**DEPARTMENT OF TRANSPORTATION**

SCL-101-R21.56  
SCL101811  
SCH2005062017

**Coyote Valley Specific Plan Project – Draft Environmental Impact Report (DEIR)**

FIGURE 2-0-10

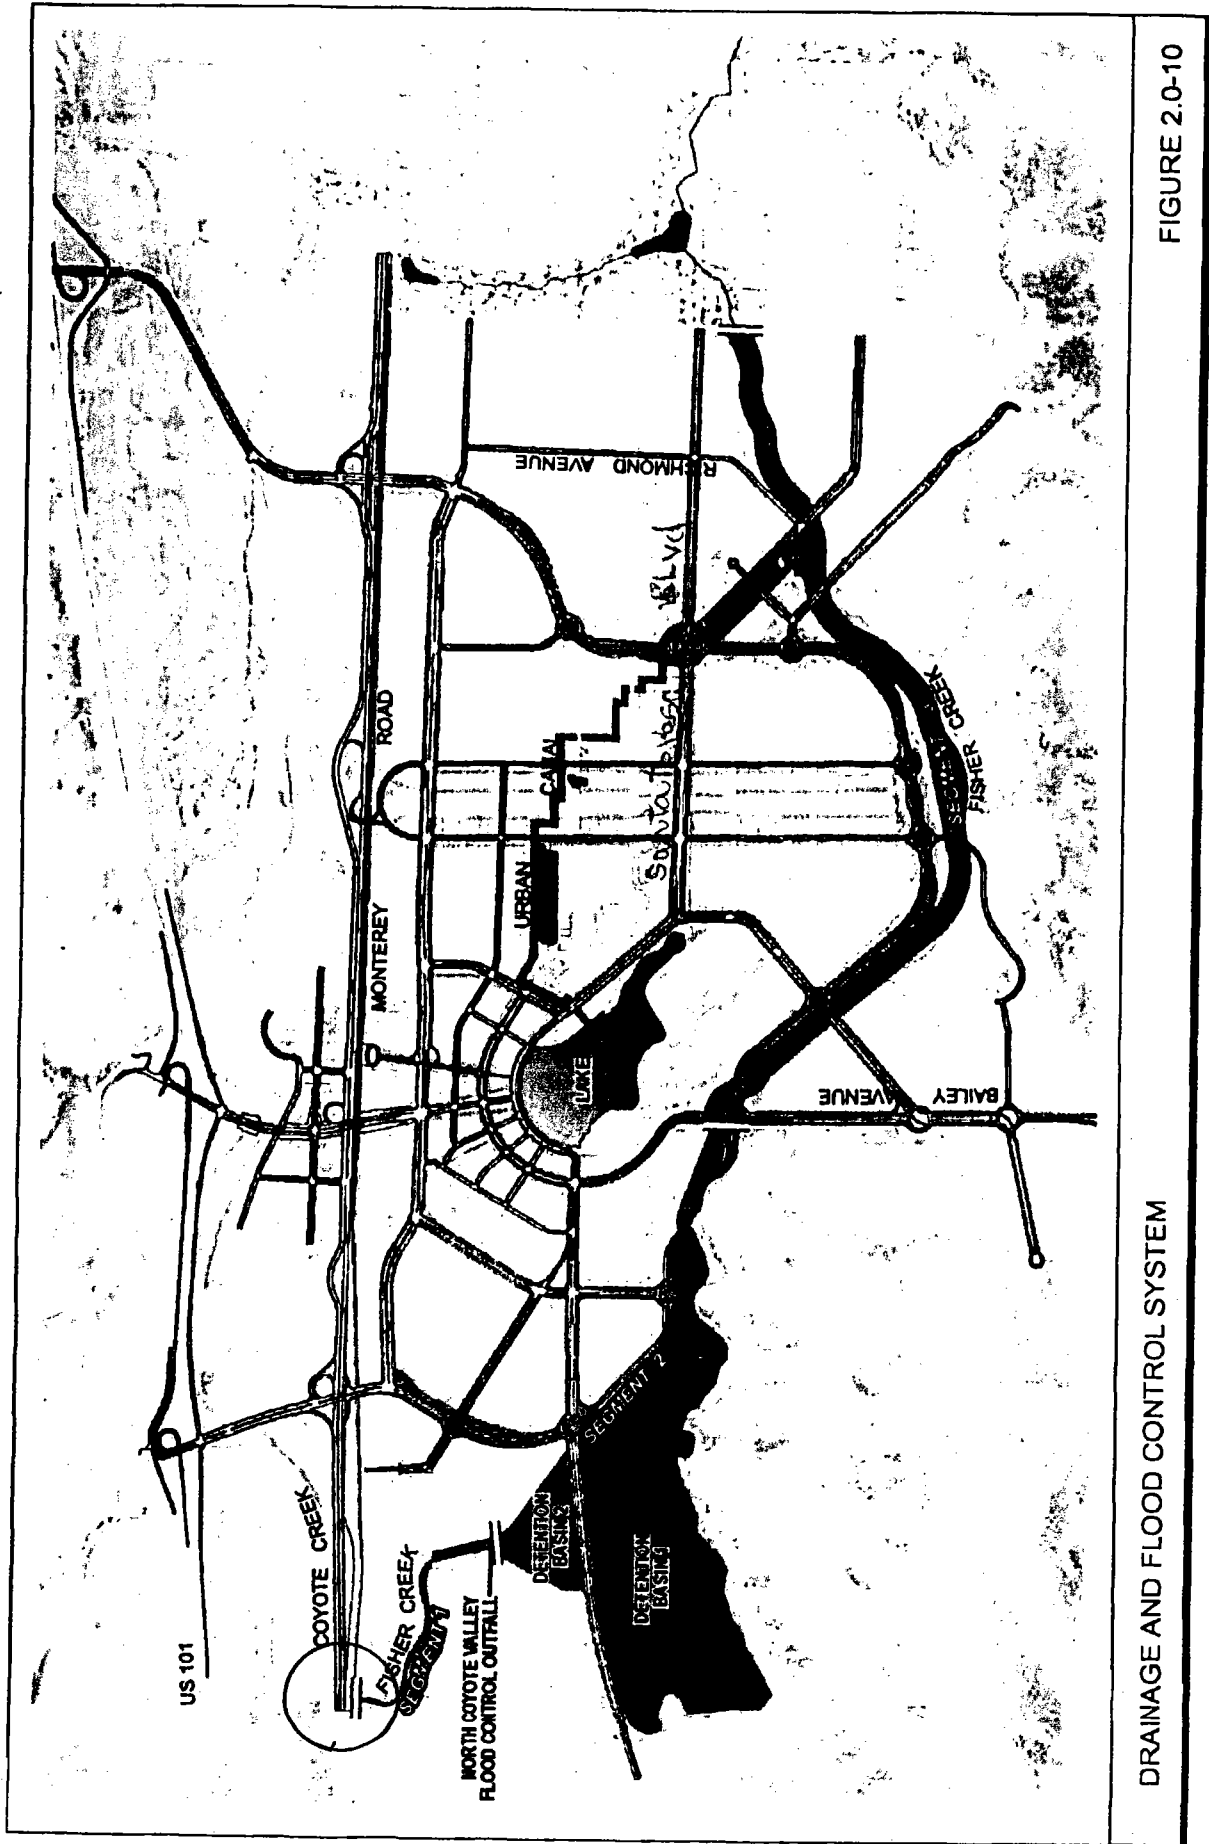
If the runoff from this development is not expected to cause significant adverse impacts to downstream areas of US-101 and Monterey Rd. (SR-82) within the development boundaries, it should be so stated with justification and back-up analysis provided. Locations of particular concern are across Coyote Creek at US-101 and across Fisher Creek at SR-82. Please see the attached maps marked with red circles.
